AXOD/AXODE (AX4S) UPDATE HANDBOOK

*Updated
October, 2002*

Since the introduction of the Ford AXOD transaxle in model year 1986, there have been many major engineering design changes that have affected many of the parts used in the AXOD transaxle. This version of the AXOD "Update Handbook" begins with the 1986 model year and will explain each change, the parts affected by the change, and any parts interchange problems created by the change. This booklet is an updated version of the original.

Figure 56

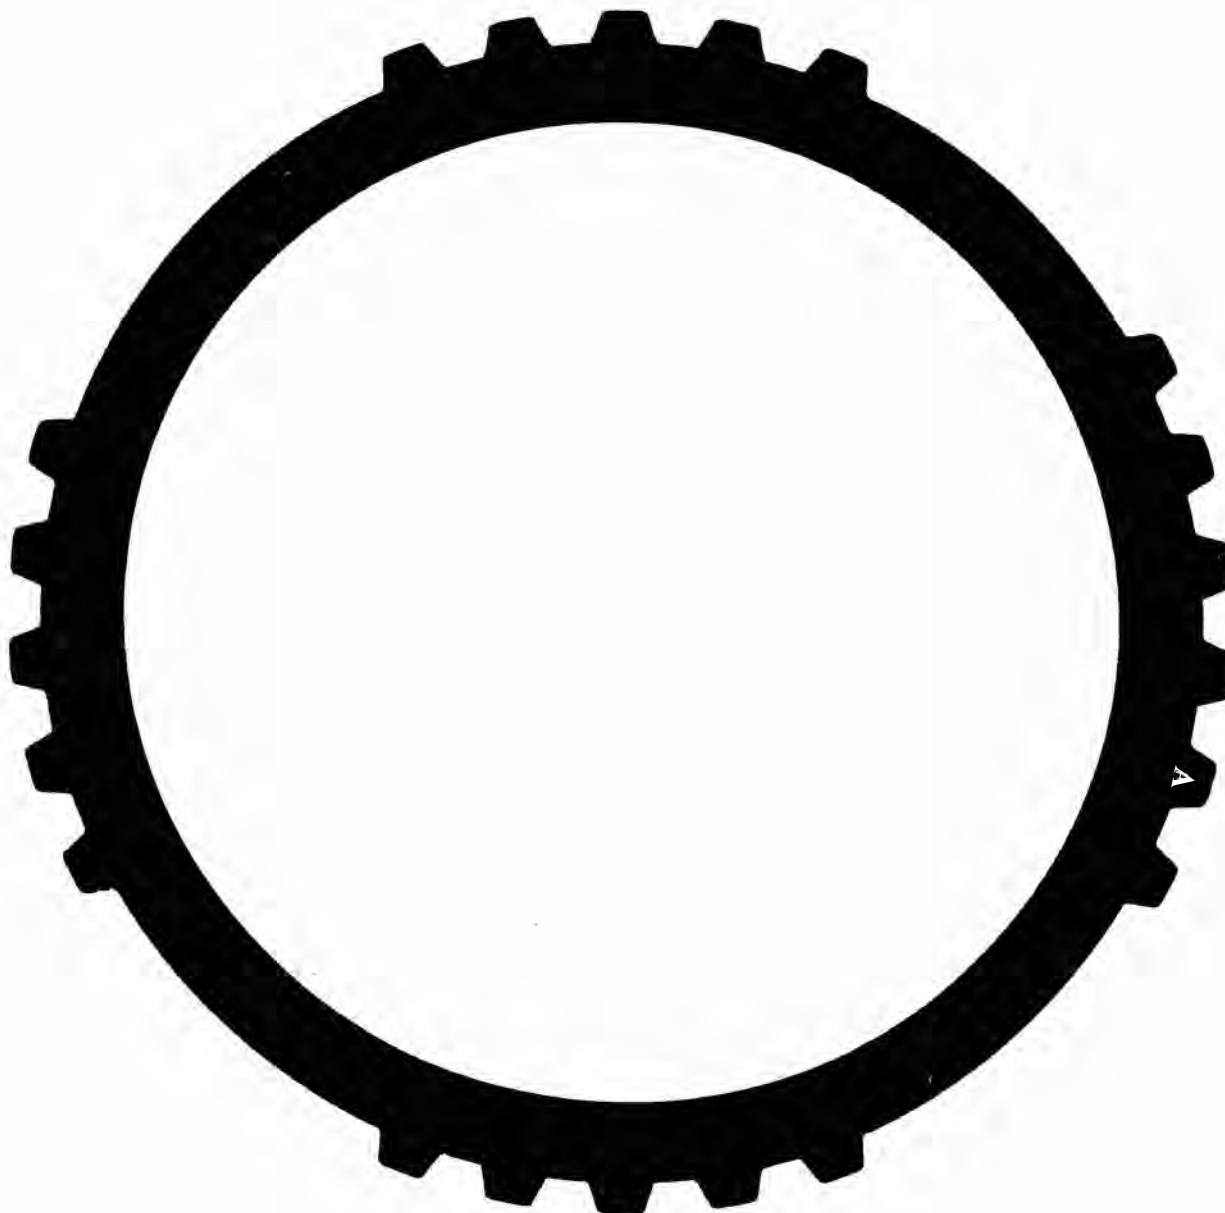
3RD DESIGN - Has 21 external teeth, inside diameter of 4.930", material thickness of .083", identified with letter "A" stamped on 1 tooth, used in 1992 and later models. (See Figure 56).

The 3rd design forward clutch wave plate was associated with a change in the entire forward clutch pack and should be used **Only** with the later design forward clutch pack, which are a larger inside diameter.

Figure 57

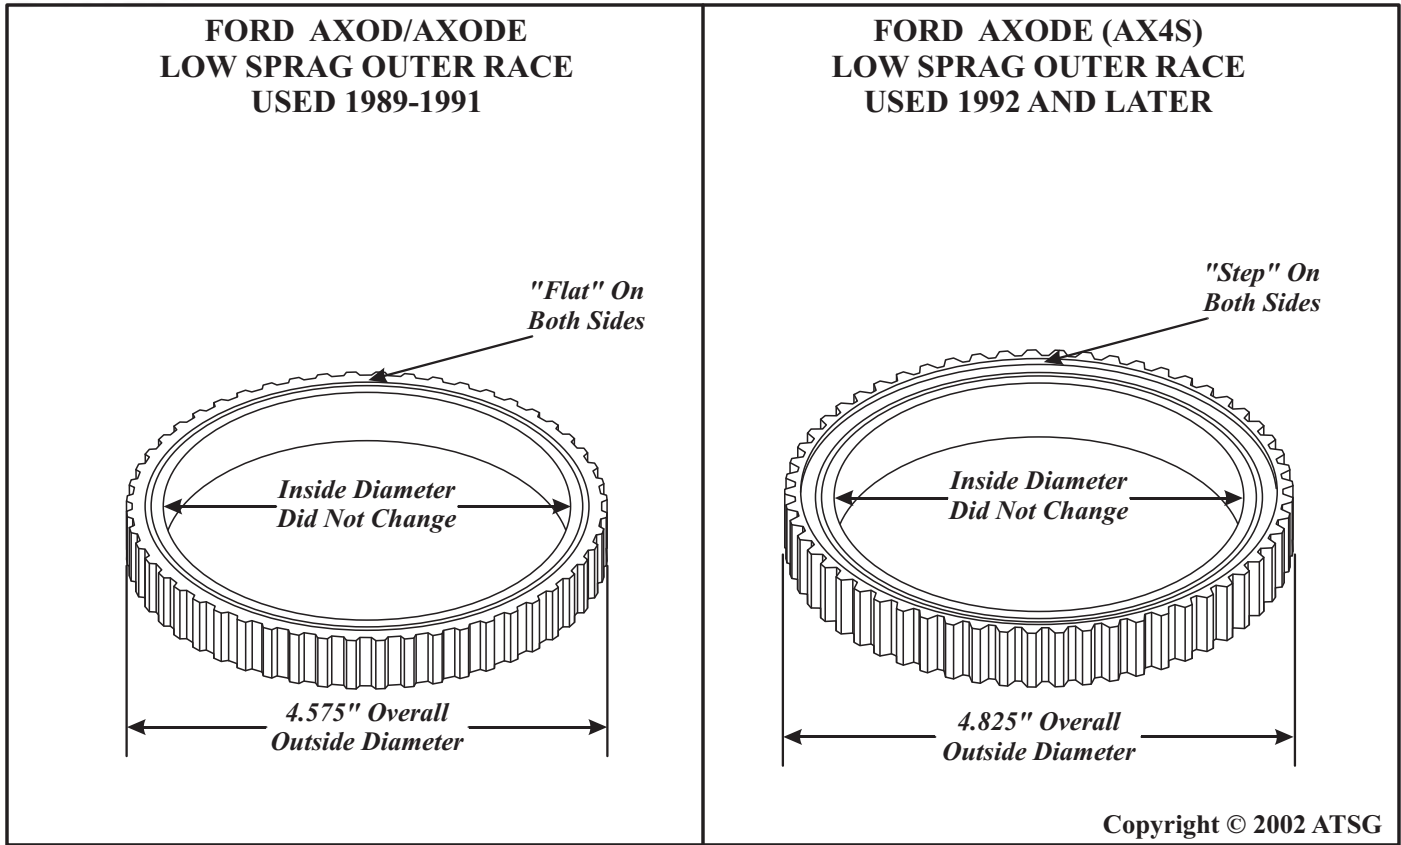
- (1) **LOW SPRAG OUTER RACE** - The outer diameter of the race was increased from 4.575" to 4.825", and the width of the race was increased from .600" to .725", as shown in Figure 57. *The Inside Diameter of the sprag race Did Not Change.*

Figure 58

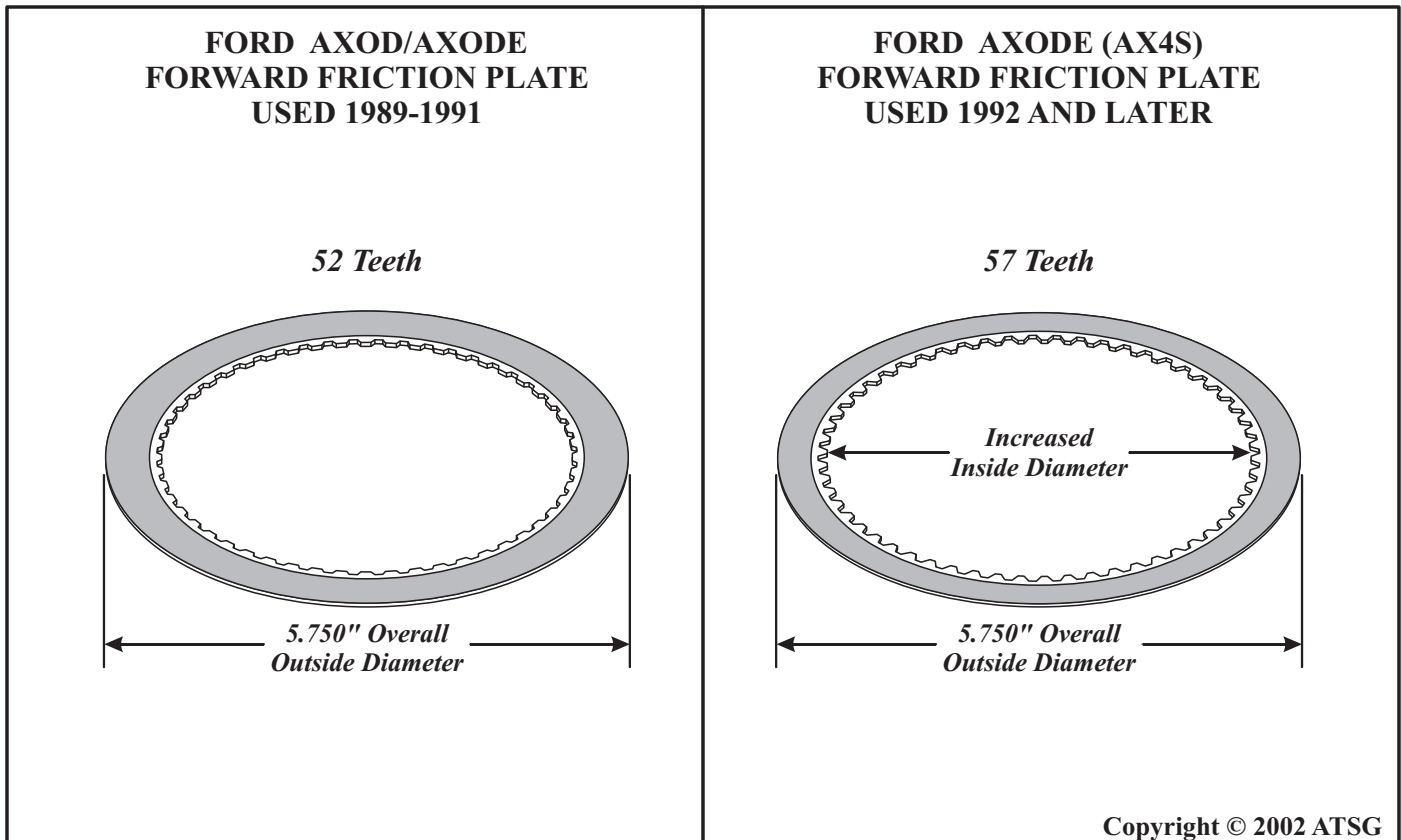
- (2) **FORWARD CLUTCH FRICTION PLATES** - Have an increased amount of teeth to 57 Teeth from the previous 52 Teeth, to accommodate the increased diameter of the sprag outer race, as shown in Figure 58.

Figure 62

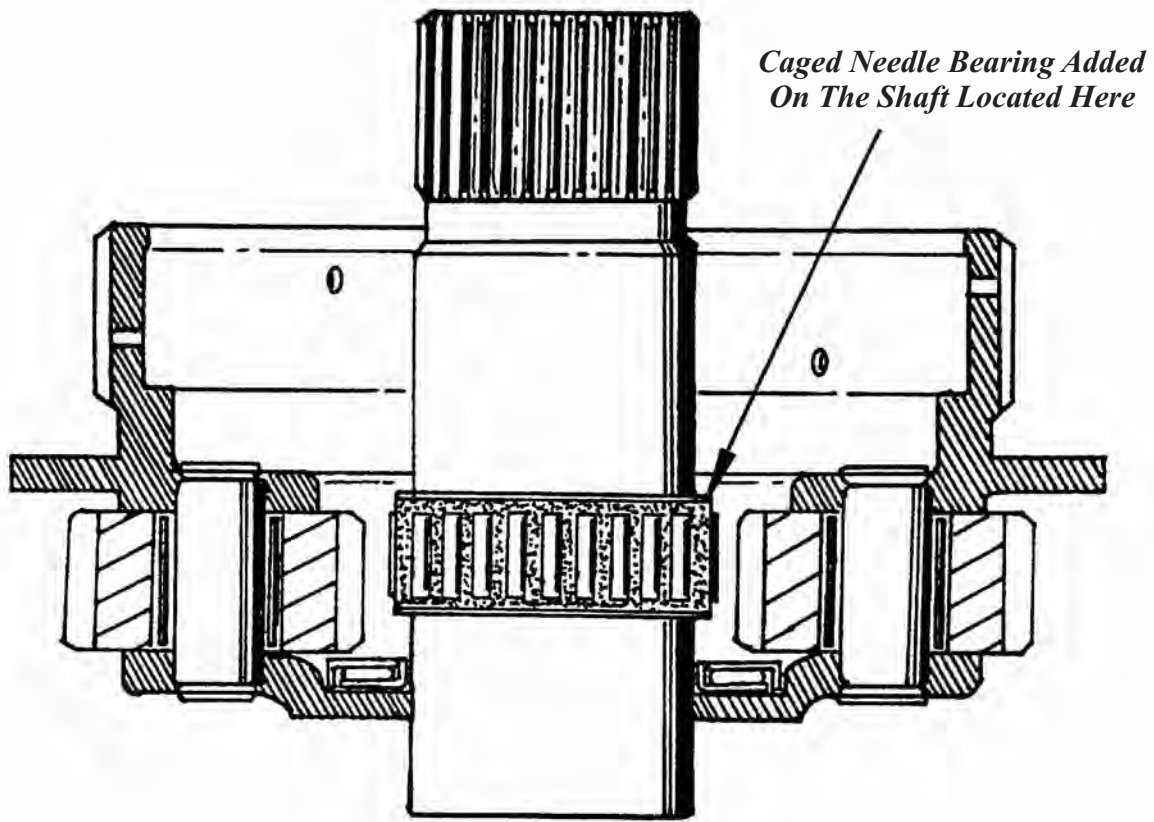
- (1) INPUT PLANETARY CARRIER - New caged needle Bearing added to the shaft on the Input Planetary Carrier, as shown in Figure 62.
- (2) SUN GEAR AND SHELL ASSEMBLY - Single bushing is now located in front of the lube holes in the sun gear, and the area behind is now machined to accommodate the new caged needle bearing, as shown in Figure 63.

Figure 66

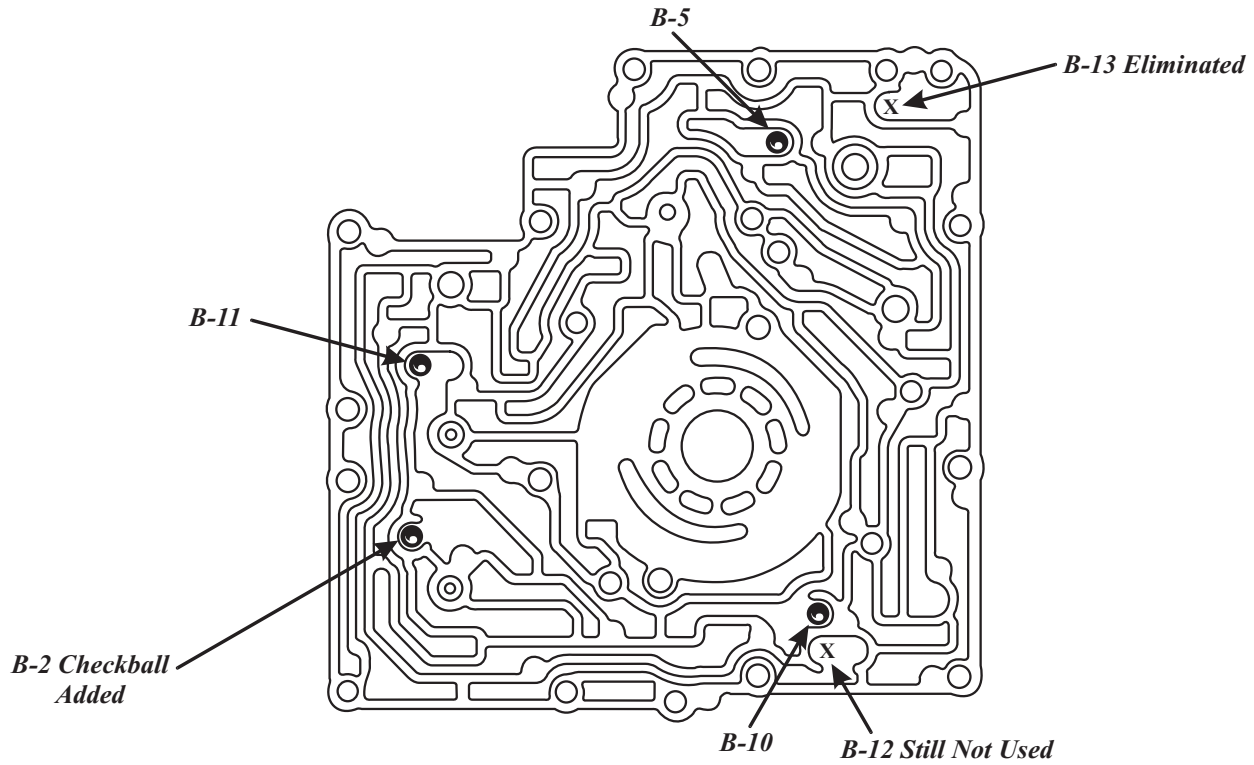
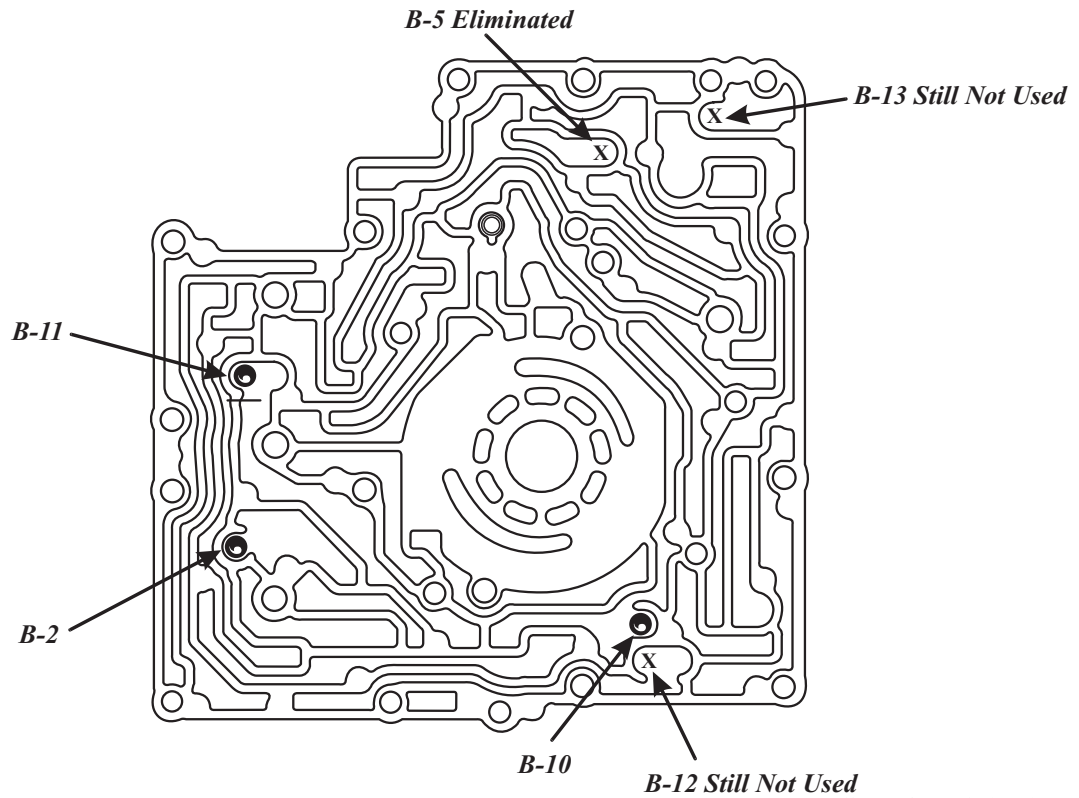
1992-1998 Only - Uses 4 checkballs but in different locations, as shown in Figure 66. B-13 checkball was eliminated and B-2 checkball was added.

1999-2002 Only - Uses 3 checkballs in the locations shown in Figure 66. B-5 checkball was eliminated.

Figure 75

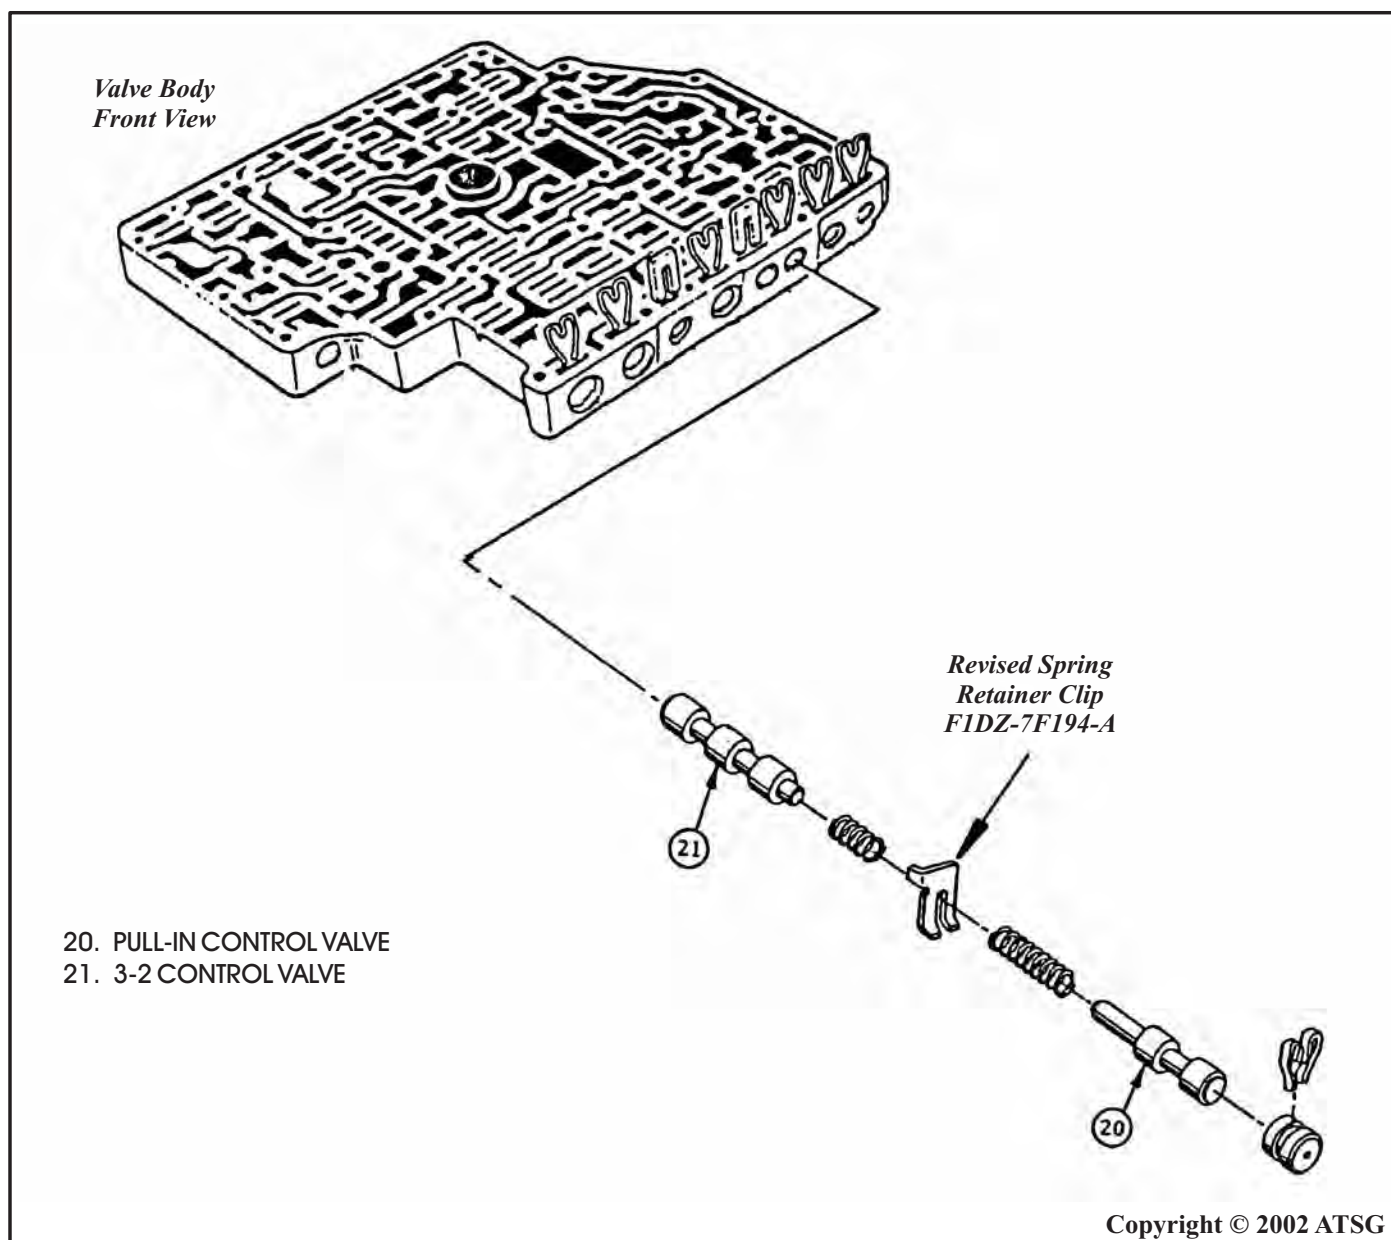
CAUSE: The cause may be, a broken spring retainer clip between the pull-in control valve spring and the 3-2 control valve spring, as shown in Figure 75.

CORRECTION: Replace the spring retainer clip with OEM part number F1DZ-7F194-A, as shown in Figure 75.

Figure 83

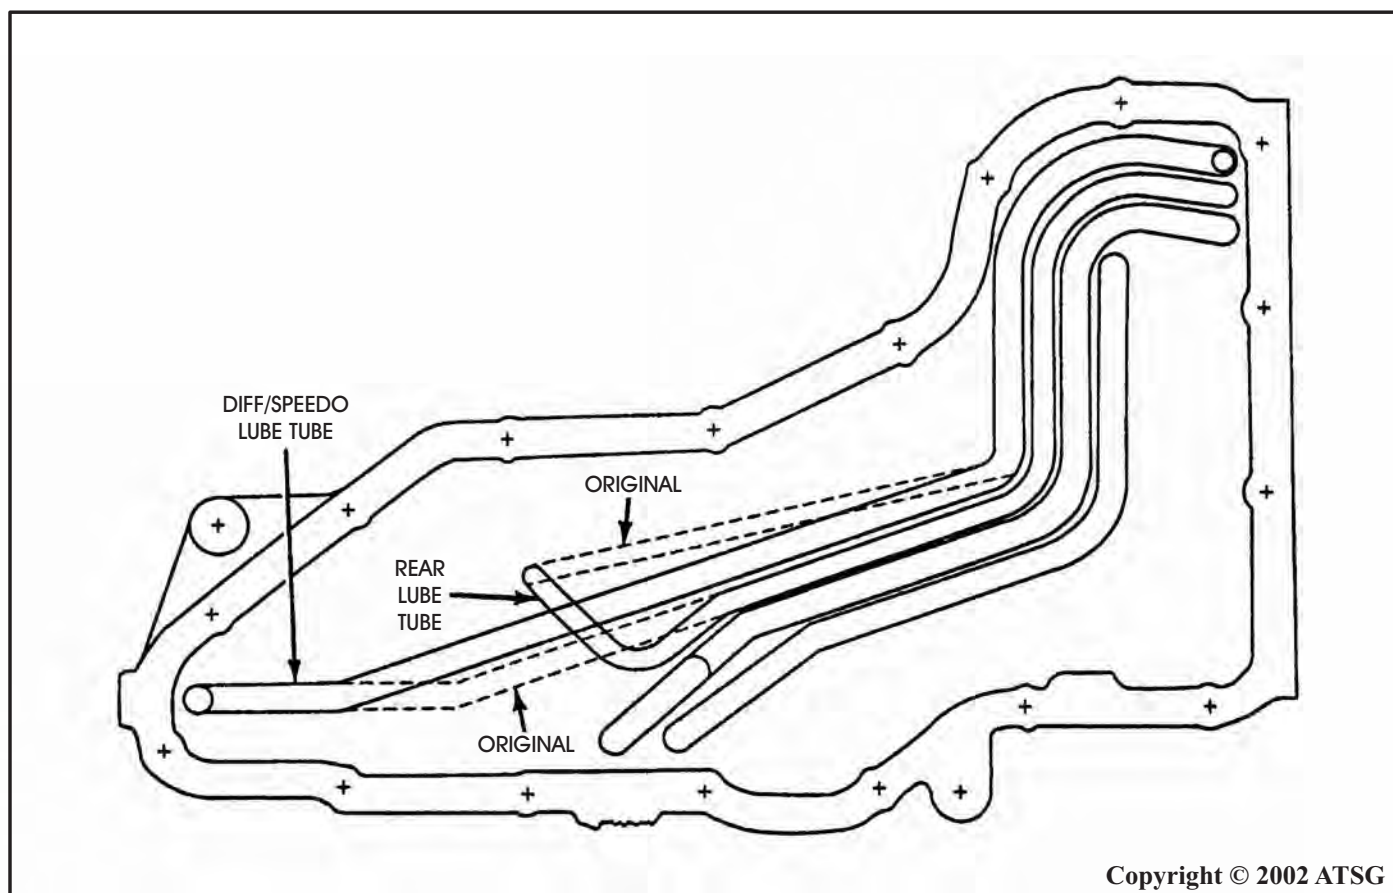
CAUSE: The cause may be, a limited volume of lube oil to the front planetary due to hydraulic control system demands.

CORRECTION: Install a new design "Cross-over" rear lube tube and a new design Differential/Speedo lube tube, that will increase the volume of lube oil to the front planetary system, as shown in Figure 83. This requires the rear lube tube to "Cross-over" the differential and speedo lube tube, as shown in Figure 83.

This change was implemented in mid-year 1992 for all AXODE transaxles.

Figure 85

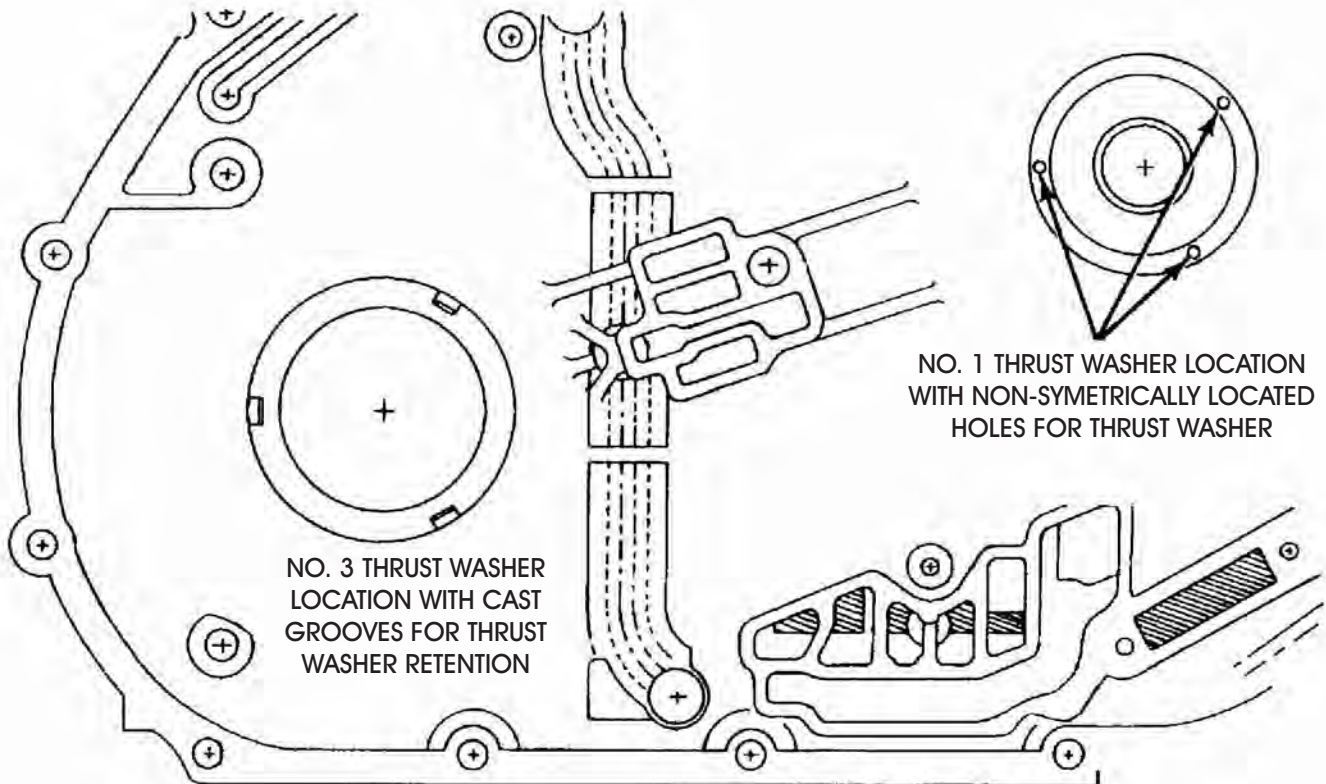
- (3) **CHAIN COVER** - New design will accept either the previous bronze No. 3 thrust washer with the tangs on outside diameter, or the new design Black plastic No. 3 thrust washer with the 3 symmetrically located tabs, as shown in Figure 86.
The previous design Chain Cover will accept **only** the bronze No. 3 thrust washer with the tangs on the outside diameter, as shown in Figure 85.
The new design Chain Cover will accept **only** the new design No. 1 thrust washer with 3 symmetrically located tabs, as shown in Figure 86.
The previous design Chain Cover will accept **only** the previous design No. 1 thrust washer with 3 non-symmetrically located tabs, as shown in Figure 85.

If replacement of the number 1 and/or the number 3 thrust washer becomes necessary, inspect the chain cover in the thrust washer tab areas to determine the correct thrust washers required. Refer to Figures 85 and 86.
